RESPONSE TO MPR TELTECH, LTD.

Prepared for Submission to the
Federal Communications Commission
in Connection with
PageMart, Inc. Request for Pioneer's Preference for Its
Personal Information Messaging Service (PIMS)

ET Docket No. 92-100
PP-40

Reply Comments to MTel Opposition Petition June 16, 1992

PCMCIA "Pager Card" Prototype
(Forerunner of PCMCIA Transceiver Card)

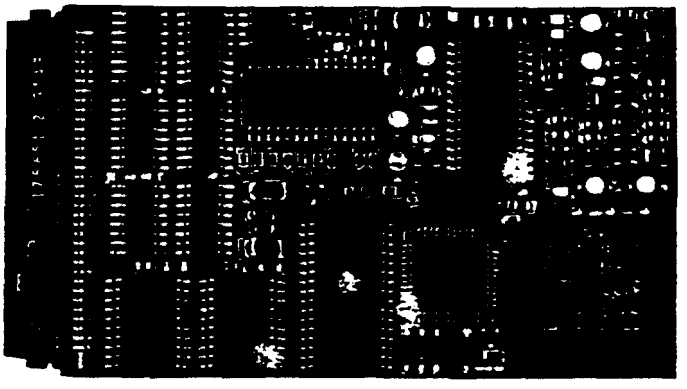
It is NWN that has the feasibility and cost issue with its yet-to-be-proven-and-tested modulation design, not PageMart. PageMart's design is well along in the PCMCIA card configuration with a first generation 2400 baud POCSAG receiver (see Exhibit 8). Adding a conventional transmitter circuit is also underway for the transceiver card.
